JOB 35-1195
Comanche Peak Steam Electric Station

Construction Procedure
DOCUMENT CHANGE NOTICE NUMBER 7

This notice applies to Construction Procedure No. 35-1195- CCP-30 Revision 10.
This change will be incorporated in the next revision of the procedure.

BROWN & ROOT, INC. CPSES	PROCEDURE NUMBER	REVISION	EFFECTIVE DATE	ARMS INDEXED PAGE
JOB 35-1195	CCP-30	10	1/26/82	1 of 13
TITLE: COATING STEEL SUB- STRATES INSIDE REACTOR BUILDING AND RADIATION AREAS	ORIGINATOR: <u>Mark L. Lellis</u> <u>1-23-82</u> DATE REVIEWED BY: <u>N/A RMD</u> <u>1-25-82</u> DATE <u>R. C. Cunningham</u> <u>1-25-82</u> B&R QA TUGCO QA DATE APPROVED BY: <u>Charles S. S. S.</u> <u>1-24-82</u> CONSTRUCTION PROJECT MANAGER DATE

Attachment 3
CZ-11 CURE TO TOPCOAT TIME
25-50% R. H.

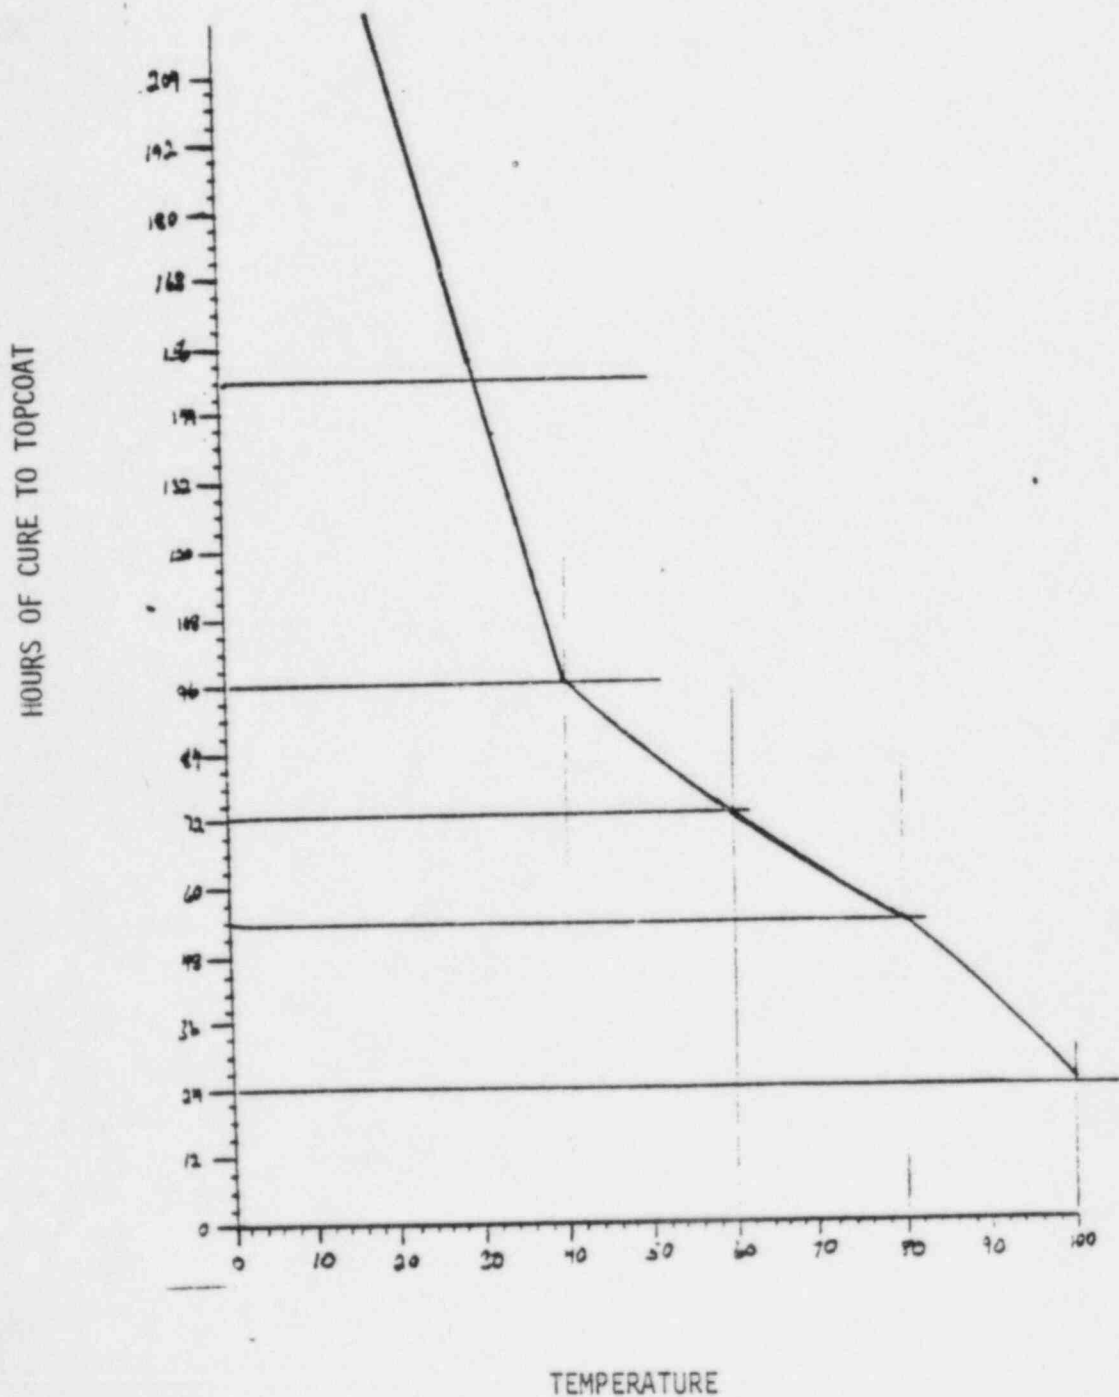
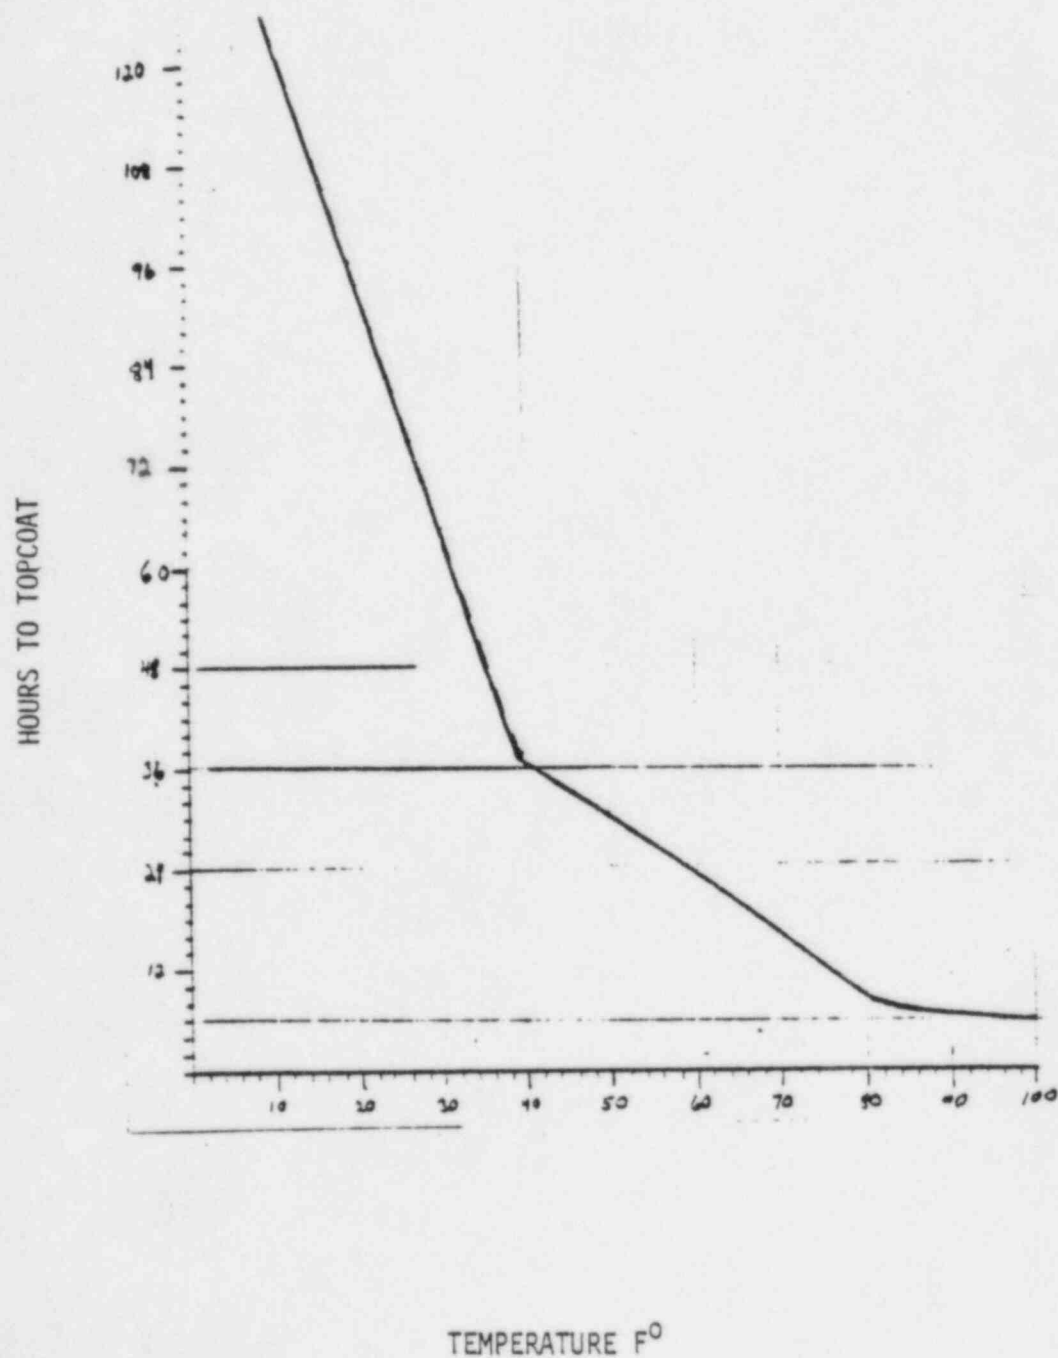
Replace the following pages with the attached:

Page 8 of 13
Attachment 3 Page 1 of 2
Attachment 3 Page 2 of 2
